# RIVER ALMOND BARRIER PROJECT, DOWIES MILL WEIR EASEMENT EXHIBITION AND ONLINE COMMENT REPORT

The City of Edinburgh Council (CEC) hosted an exhibition and mechanism to make comment on detailed proposals to ease the current barrier to fish migration at Dowies Mill, River Almond from 21/01/2019 – 25/02/2019. Additional support and expertise was provided by Scottish Environment Protection Agency (SEPA) Restoration Specialist and members from the Forth Rivers Trust (FRT).

Figure 1: Water Quality in the main stem waterbodies of the Almond catchment

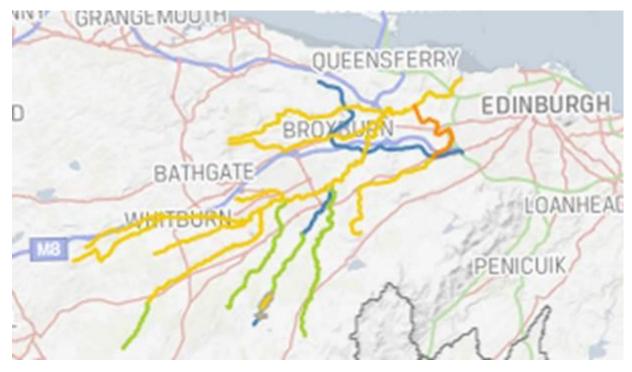
Public quote: "Where are the figures or survey results of the impact of the new fish ladder further down the River Almond towards Cramond?"

The majority of the catchment has either moderate, good or high water quality (Figure 1). Fish abundance could be particularly high in the middle and upper catchment where the higher water quality reaches exist. Ensuring migration into these areas is therefore important. Removing barriers would consequently be expected to improve salmon and other fish distribution considerably throughout the catchment.

Overall, removing barriers to migration on the Almond would, over time, be expected to result in most of the fish communities achieving at least a moderate condition. This would represent a considerable improvement on the present classification and expand the distribution of salmon and other fish in the Almond, with consequent increases in smolt output and adult returns. Water quality problems are unlikely to cause significant chemical barriers to migration, as shown by other successful examples of salmonid restoration elsewhere in Scotland (the well documented recovery of salmon in the Clyde being an example).
